APPENDIX B

**RCC PLACEMENT BY LANE METHOD – BWA’S PROPOSAL, TRP COMMENTS ON
PROPOSAL AND BWA’S PROPOSED SPECIFICATION CHANGES
25-27 JULY 2012**

Memorandum

Reference No: GHD-ECD-GEN-DAM-TMM-0101-0

Appendix A Lane Configuration

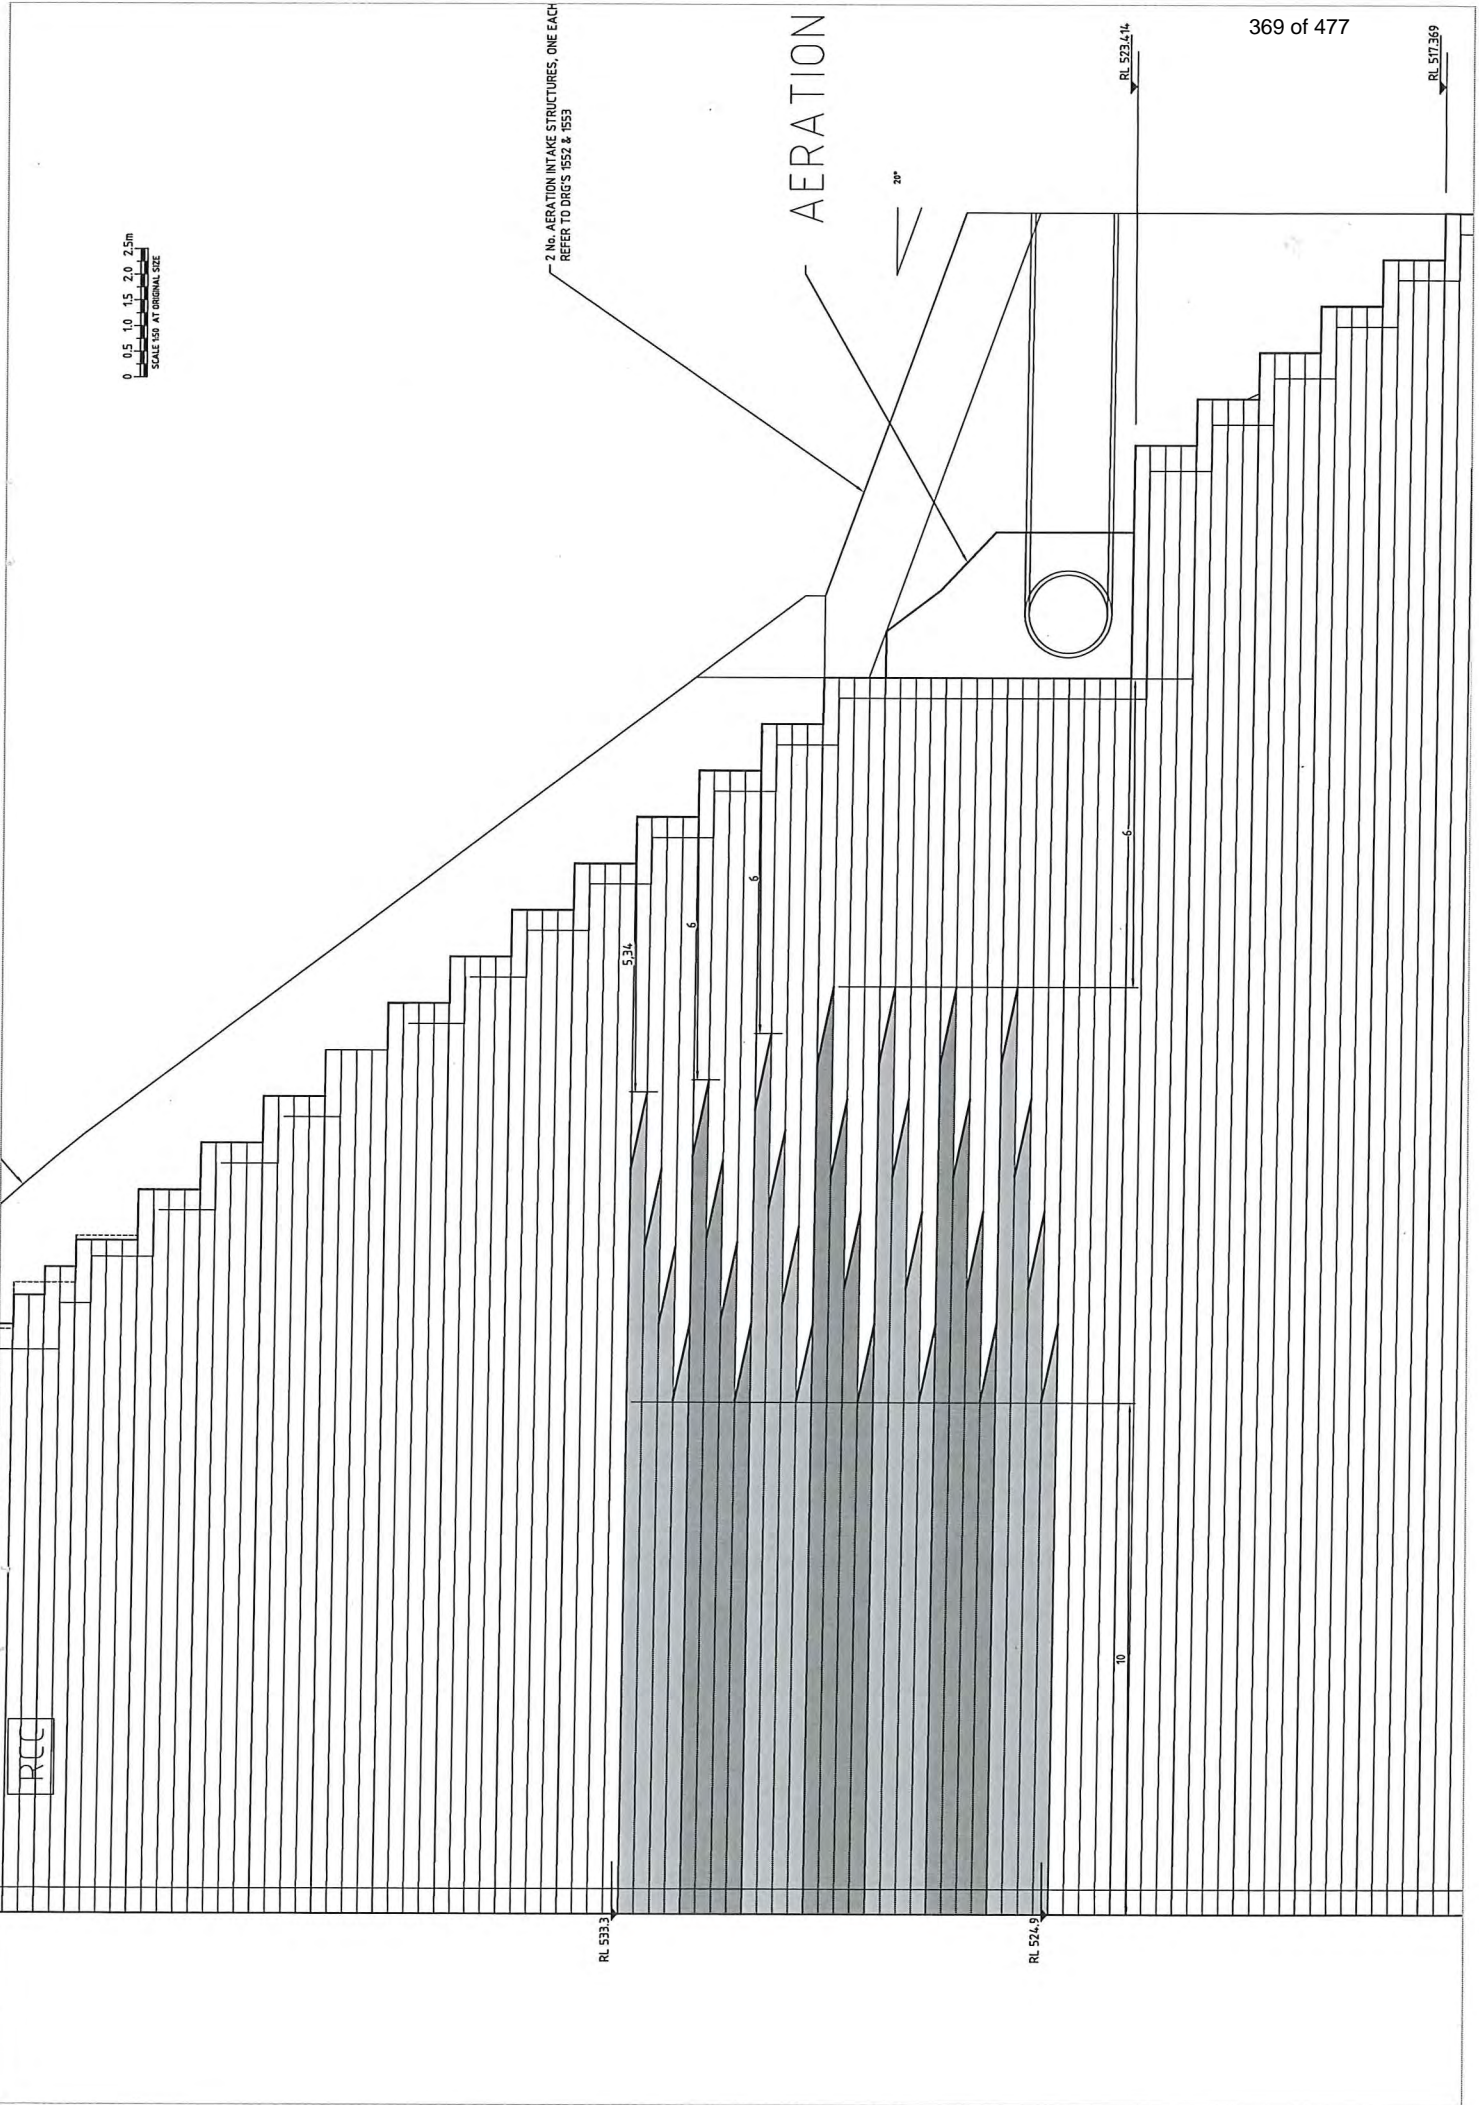
The proposed methodology is to place a lane (or strip) of RCC against the upstream form. The downstream edge of the RCC would be rolled off and compacted as the lane proceeds from one abutment to the other. The downstream portion of the dam would be completed by the next lane of RCC.

- The location of the lanes will be as per the attached sketches (Refer Appendix A). The lane placement methodology will not continue above the level shown (RL 533.3m). Other placement strategies will be adopted beyond this level, which may include an external pedestrian access way and drive on access in some areas.
- The interface between the lanes is offset from the one below by 1.5-2m. The intended arrangement has a lane ending in the same plan position only on every fourth layer.
- The upstream lane will not be less than 10m wide to ensure the upstream 6 m can be suitably protected..

- The downstream edge of the RCC will be "rolled off" at approximately 6H:1V (as per the specification) and will be covered with wet hessian after compaction. The slope of the roll-off makes it difficult to continuously water cure via other means.
- The lanes will be marked out by survey.

- The interface between the lanes has been offset on subsequent layers so that the intersection of lanes occurs in the same plan position only on every fourth layer. This minimises the potential for a continuous plane of weakness to be developed.

I have read the submission and can see why the team is wanting to go this way, the safety risks together with the real quality issues probably don't give us much option. I would certainly prefer not to place in lanes but have experienced this before due to similar issues on another project. The proposed methodology has been very carefully thought out and appears ok for the section proposed provided there is a REAL improvement during the proposed trial lifts in all areas of Safety, Quality and Production. The staggered interface is endorsed. I would make the following points:-

- 1 The staggered interfaces are to be closely monitored
- 2 The rolled over edges are to be compacted correctly with any resultant feather edges cleaned back and adequately treated. Curing of the rolled edges is critical, the use of wet hessian or similar is required and should be closely monitored.

- 3 Ensure that the proposed treatment of the U/S 6 m is enforced. This section should be treated as a "sacred" zone with traffic disturbance kept to an absolute minimum.

- 4 The congestion and related safety concerns will only increase as we get higher which highlights the need for drive on/off access where possible.
- 5 The proposed change to the specification should be restricted to the section proposed up to EL 533.3 provided the trial lifts demonstrate a real improvement in safety, quality and production. Thought needs to be given now to construction methodology for the remaining dam above EL 533.3.
